Docket Item # 4
BAR CASE# 2009-0035

BAR Meeting
June 17, 2009

ISSUE: Alterations and Waiver of HVAC Screening

LOCATION: 202 Duke Street

Figure 3: View of Property from Public Alley

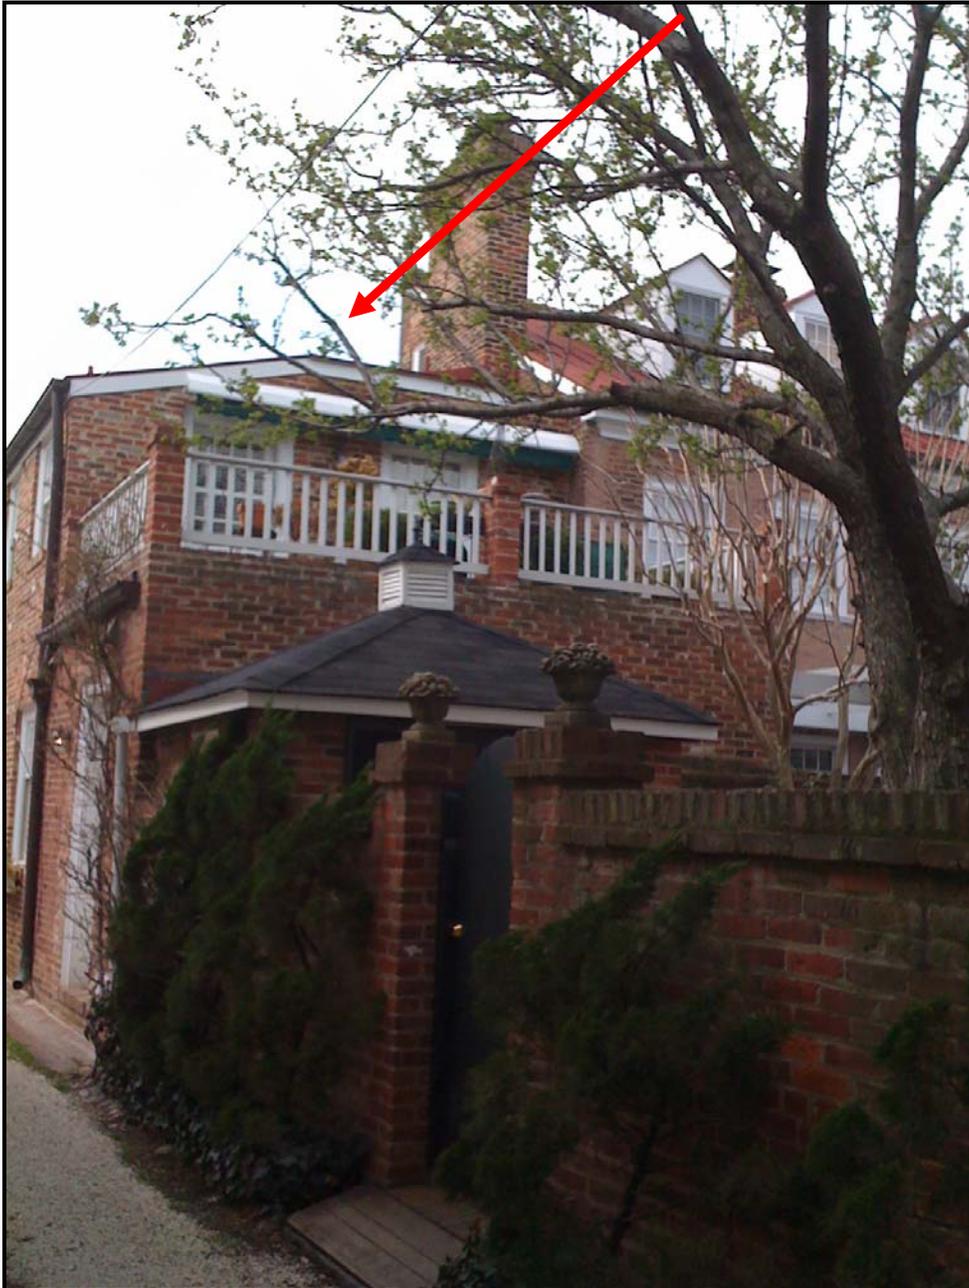
The revised application also provides the Board with additional information on the potential visual impacts that the proposed condenser’s rooftop location will have to the existing historic district’s streetscape. The attached photo montage documents the applicant’s mock-up created at the request of Staff. The details of the mock-up included installing a single cardboard box measuring approximately the size of one of the two proposed condenser units and generating the attached photo collection. Although Staff would have hoped that this mock-up would have been a true representation of the proposed conditions, not utilizing only one box to represent the two units, we commend the applicant for providing this level of visual detail for the neighbors and the BAR. As previously stated in the April 1, 2009 Staff report, the *Design Guidelines* encourage HVAC equipment to be “hidden from view.” Affixing HVAC equipment on a roof structure is viewed by the *Guidelines* as a last resort, when conditions prevent an applicant from installing the equipment

elsewhere on the property. Since there are locations in the garden for these units to be appropriately installed, Staff continues to recommend that the compressor units be located in an inconspicuous location on ground level. If the applicant strongly desires not to install the units on the ground level, an above-ground alternative is to install the condenser units on the dwelling's second level rooftop deck, which is surrounded by an existing wood balustrade. However, if the Board finds the proposed roof mounted units suitable and approves the units to be installed on the roof structure, upon review of the photographs taken during the mock-up, Staff feels the condensers will not be highly visible from the existing rights-of-way.

Approximate Location of
Condenser Units

Figure 9: Dimensions of Proposed Condenser Units

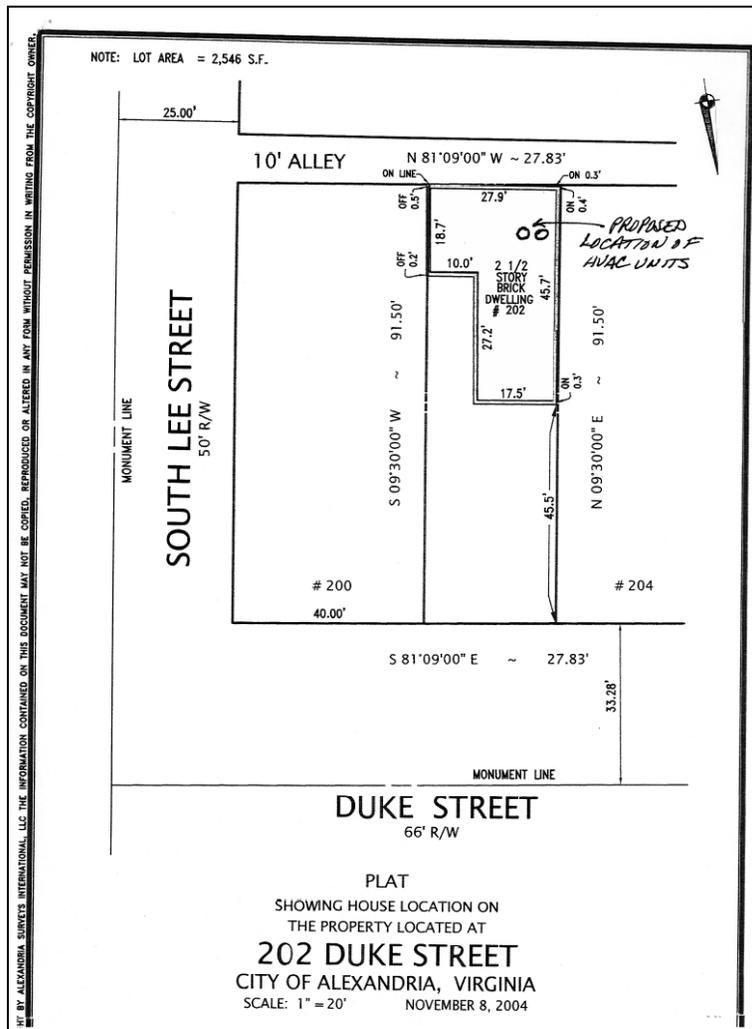
Dimensions of HVAC Condensers to be relocated:

Unit #1 – 23"W x 28"D x 22"H

Unit #2 – 29"W x 34"D x 27"H
